Whistling Ridge Energy Project

Final Environmental Impact Statement

Appendix H

Appendix H: COMMENT LETTERS

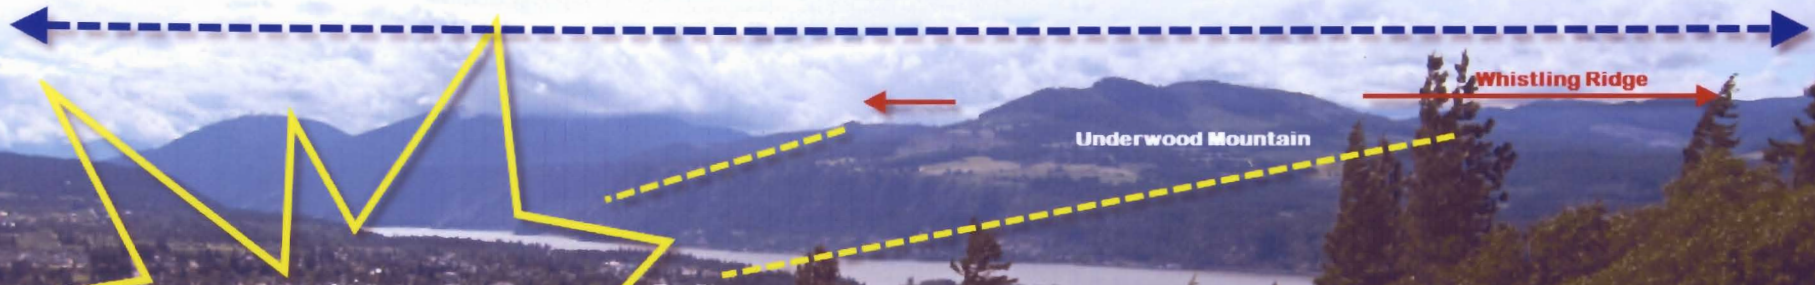
2. Typical Cloud Line - Proposed **Whistling Ridge** turbine string will be in cloud/fog for part of the year. **Impact on birds, aviation?**
This is not covered in the EIS.

Figure 1-Graph Of Wind Turbine Sounds Vs. Rural Background And Threshold Of Perception

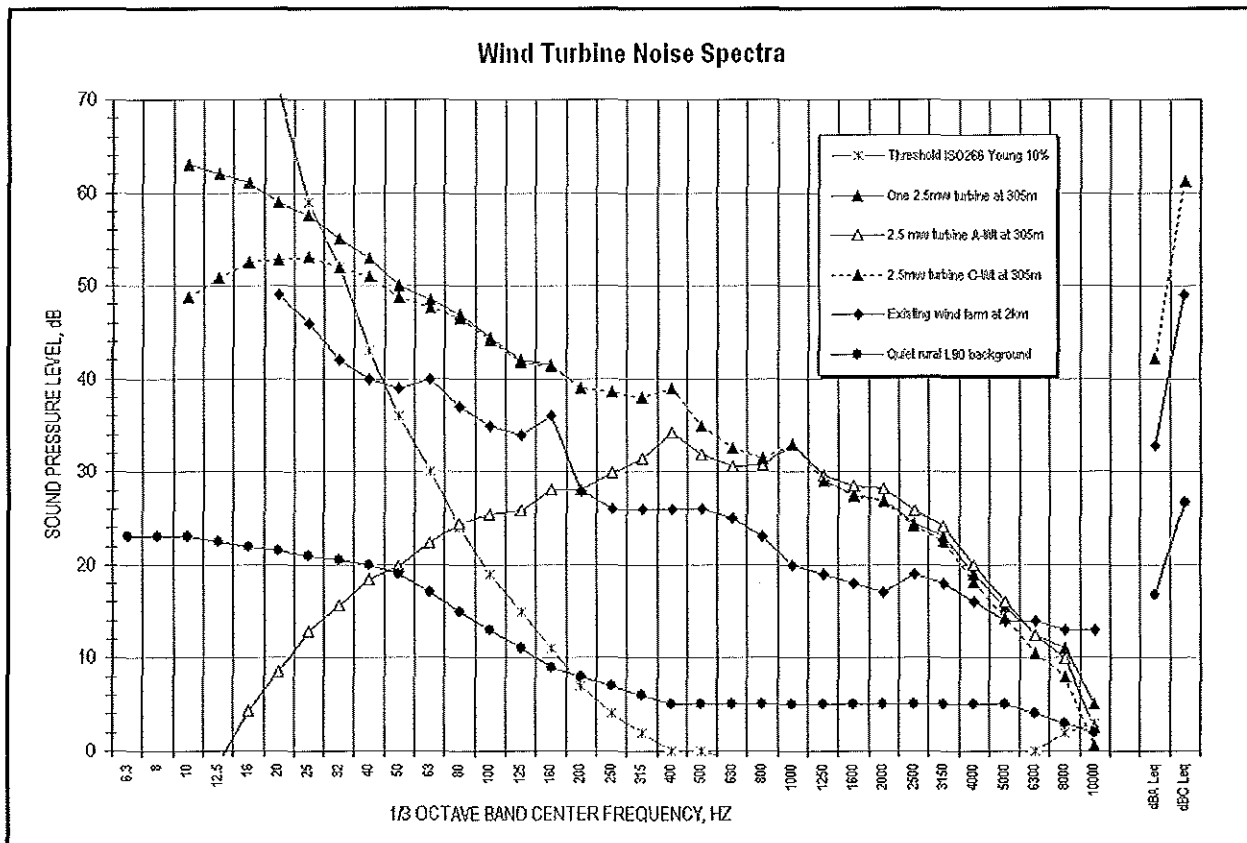
The over-all sounds from each of the frequency bands are summed and presented on the right hand side of the graph. These are presented with corrections for A-weighting (dBA) and C-weighting (dBC). These show that if only dBA criteria are used to assess and limit wind turbine sound the low frequency content of the wind turbines emissions are not revealed. Note that in many cases the values for dBC are almost 20 dB higher than the dBA values. This is the basis for the WHO warning that when low frequency sound content is present outside a home dBA is not an appropriate method of describing predicted noise impacts, sound limits, or criteria.

residents. For the conditions shown in Figure 1, the distances would need to be increased significantly. This would result in setbacks in the range of 1 km or greater for the current generation of wind turbines if they are to be located in rural areas with little or no low frequency sound from man-made noise sources and where the L_{A90} background sound levels are 30 dBA or lower. In areas with higher background sound levels, turbines could be located somewhat closer, but still at a distance greater than the 305 m (1000 ft.) or smaller setbacks commonly seen in U.S. based wind turbine standards set by many states and used for wind turbine developments.

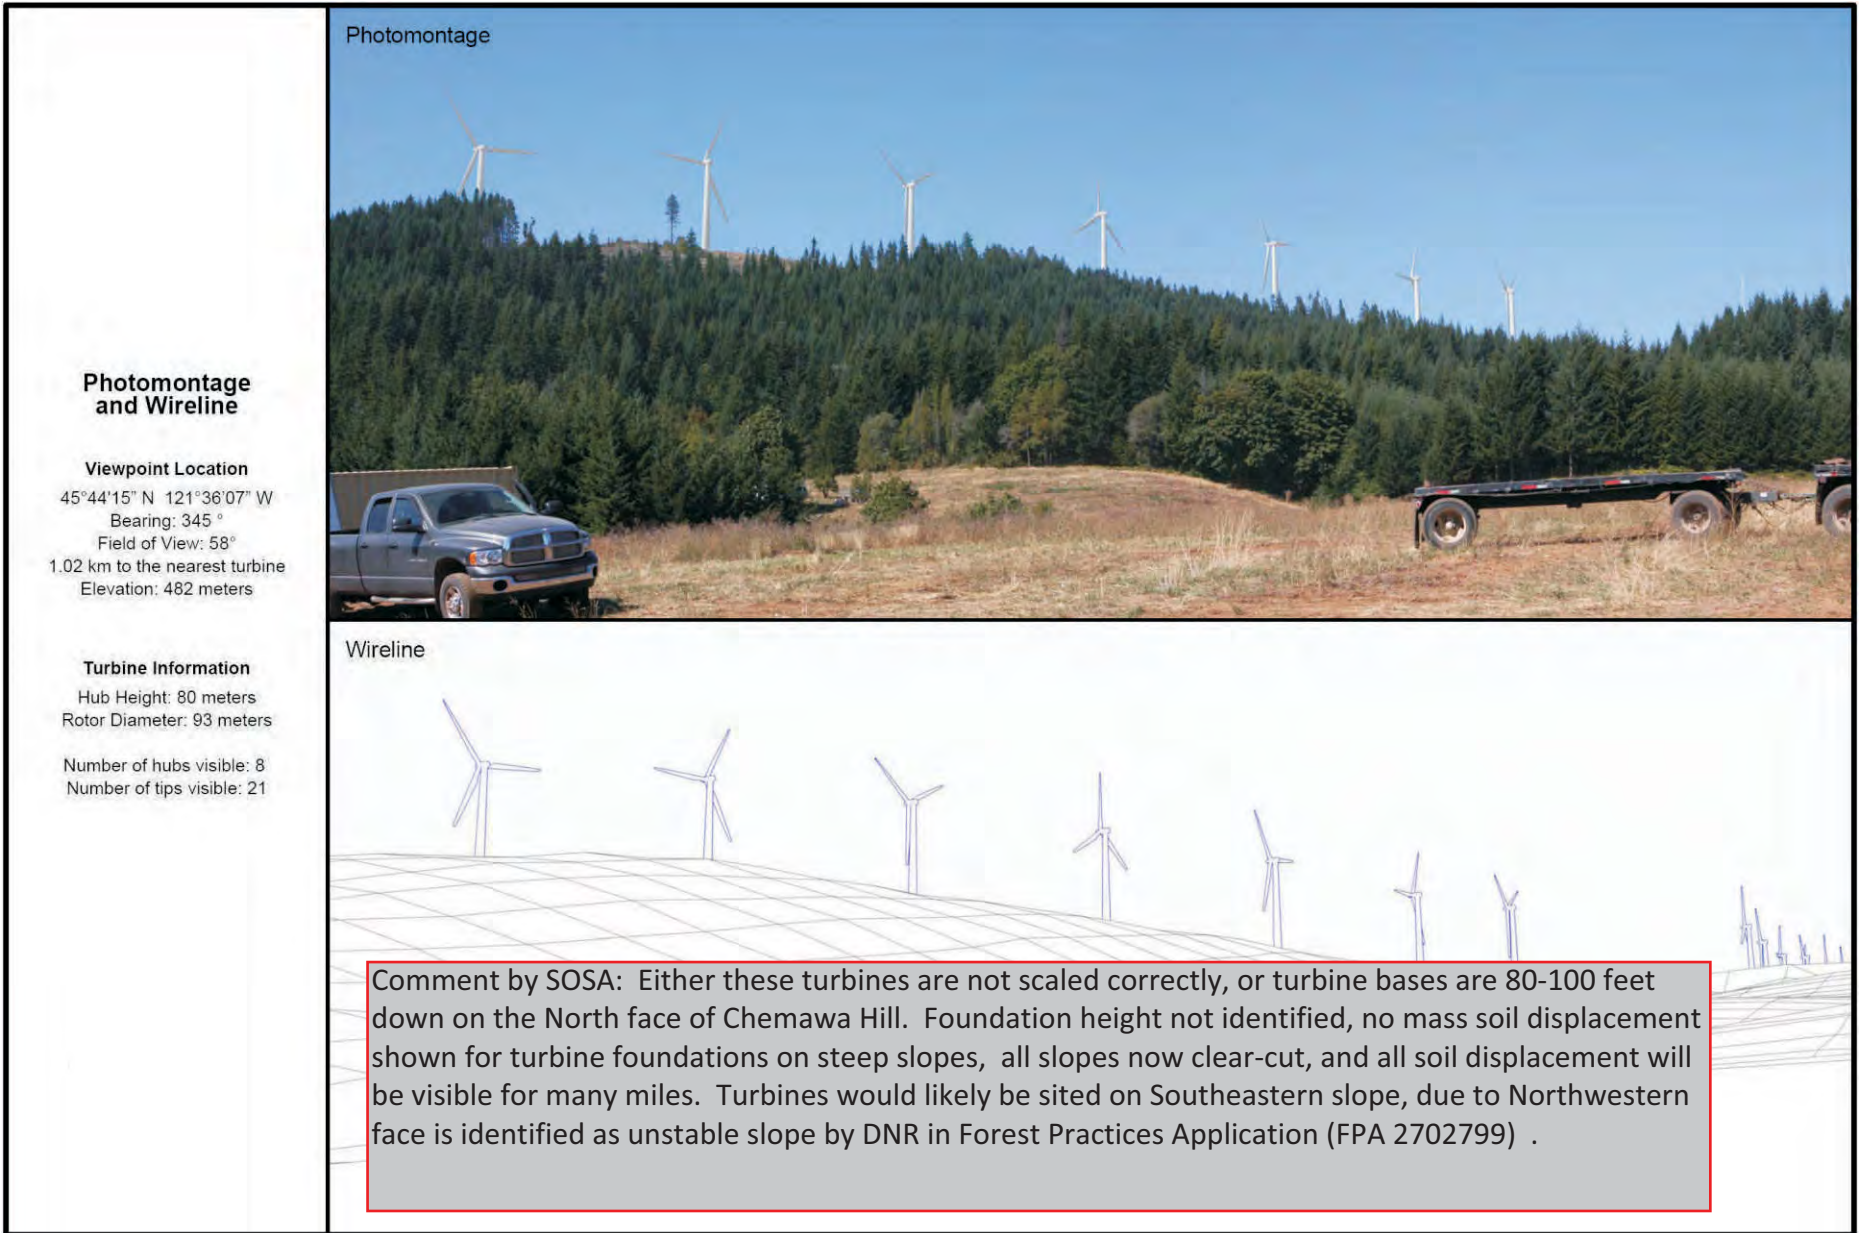
Comment by SOSA:

Due to clear-cutting of the A-Turbine String Ridgeline this summer 2010, the visuals boxed in RED above, must be re-created using new photographs and properly scaled Turbines on a worst case contrast ratio. Topographic changes must also be included, per

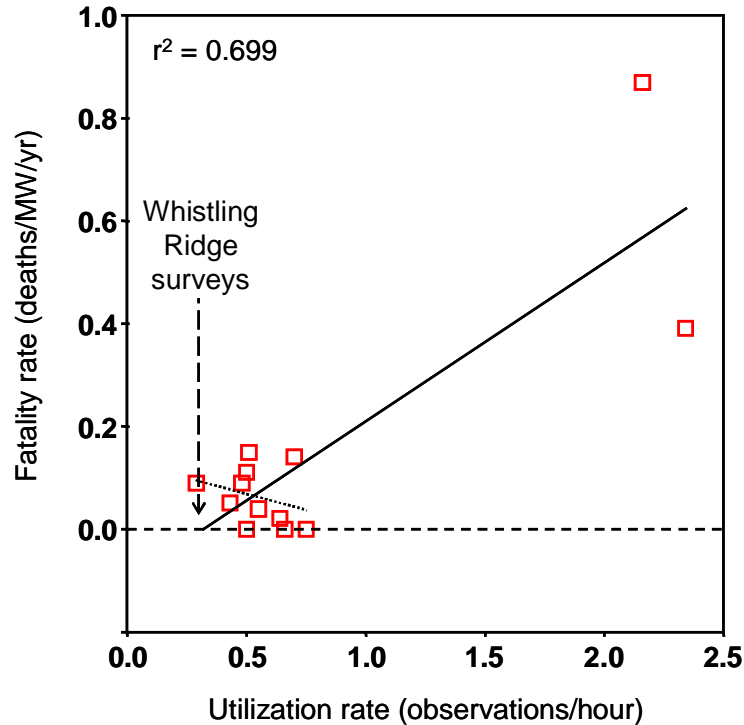
WEST, Inc. relied on a regression relationship (*Figure 8* in App. C-4) that regularly appears in their environmental documentation in support of wind energy projects, and which I have commented on before (see *Figure 1*, below). Affirming its reliance on the WEST, Inc. approach to assessing potential project impacts, the DEIS (page 3-63) stated, “*Mean overall bird use in the study area was low compared to these other wind resource areas studied: ranking 19th compared to 24 other wind resource areas...*” and, “*Mean annual raptor use was 0.28 raptors per plot per 20-minute survey, which is a standardized way to measure use in order to compare results to avian use at other sites.*” However, this approach was inappropriate for use as a predictive tool due to multiple fundamental flaws, which are addressed in the following paragraphs.

Sufficiency of survey effort.—The vertical dashed arrow in Figure 1 represents the utilization rate that WEST, Inc. estimated for raptors at the Whistling Ridge project site. Although a non-biologist might be impressed with the number of bird surveys performed at the Whistling Ridge project site, totaling 261 surveys, biologists familiar with utilization surveys at wind project sites have cause for concern regarding conclusions drawn from the level of effort devoted to Whistling Ridge. The 261 surveys lasted 20 minutes each, so totaled 87 hours. Eighty-seven hours was insufficient time to detect multiple raptor species and many other bird species, especially considering the high levels of visual occlusion due to forest cover surrounding observation stations at Whistling Ridge, along with the large volumes of airspace that would have been occluded due to mountainous terrain and cloudiness.

Figure 8. Fatality rate estimates regressed on utilization rate estimates after including data from additional WRAs to those used by WEST, Inc.

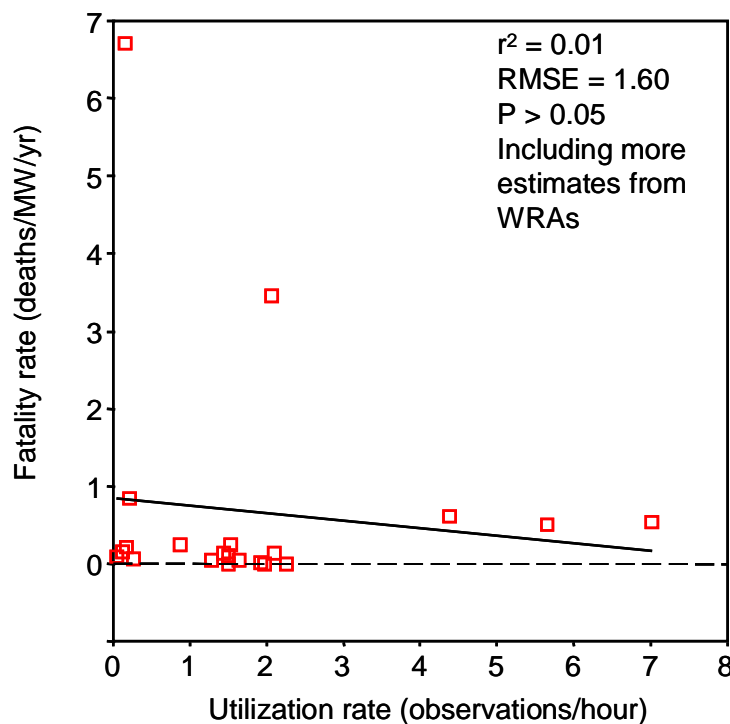
Regression relationship based on selective inclusion of data.—*Figure 8* of App. C-4 was based on only some of the wind projects for which there exists fatality rate and utilization rate estimates. Including more of the estimates available, the regression slope reported by Johnson et al. in the Whistling Ridge DEIS no longer applies (*Figure 8*).
